Pentium® II Xeon™ Processor Specification Update

Release Date: July 1999

Order Number: 243776-014

The Pentium® II Xeon™ processor may contain design defects or errors known as errata which may cause the product to deviate from published specifications. Current characterized errata are documented in this Specification Update.

D30. Thermal Sensor May Assert SMBALERT# Incorrectly

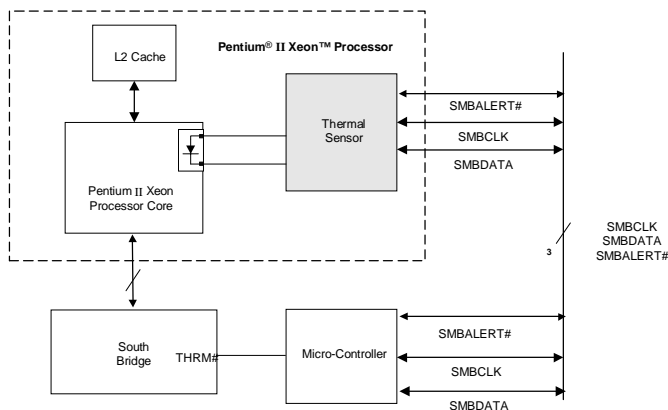
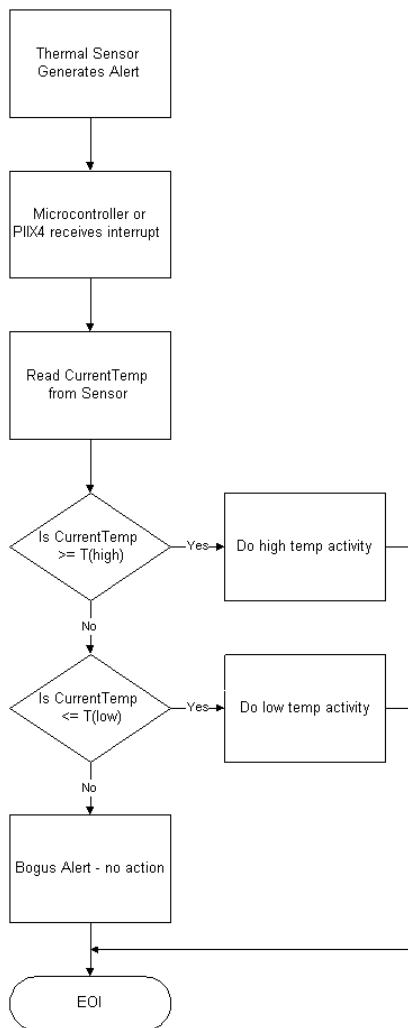
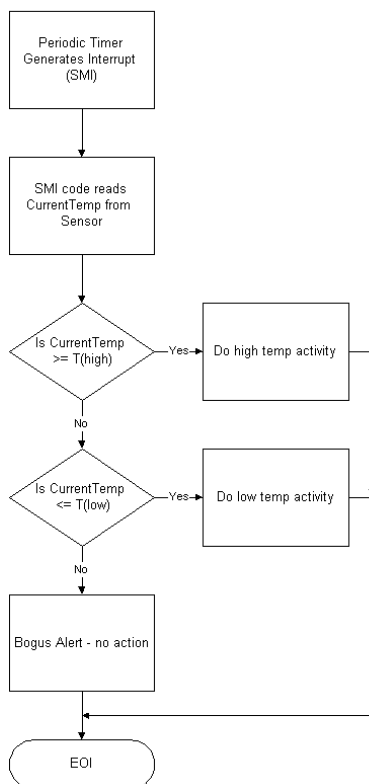
PROBLEM: The Pentium II Xeon processor has a thermal sensor that monitors the processor core's temperature. The thermal sensor asserts SMBALERT# if the processor temperature exceeds the temperature limits set in the Alarm Threshold Registers (T_{HIGH} , T_{LOW}). It also sets the corresponding Status Register bits to identify the cause of the interrupt. Figure 1 gives one example of the how the SMBALERT# signal could be used in a system.

Under the conditions described below, the thermal sensor incorrectly generates the SMBALERT# interrupt. *All* of the following conditions must be met to trigger a false interrupt:

WORKAROUND: Three different (mutually exclusive) workarounds are possible:

1. Before servicing an interrupt from the thermal sensor, read and compare the processor thermal reading with the threshold limits (T_{HIGH} or T_{LOW}). Figures 2 and 3 provide basic flowcharts for the implementation of this workaround in an interrupt driven system.
2. If the firmware implemented polls the Status Register only, then before taking any action, re-read the temperature register and do a comparison with the alarm threshold limits (T_{HIGH} or T_{LOW}) to determine if the value is actually still within the temperature window.
3. Use a temperature polling scheme to monitor the processor temperature.
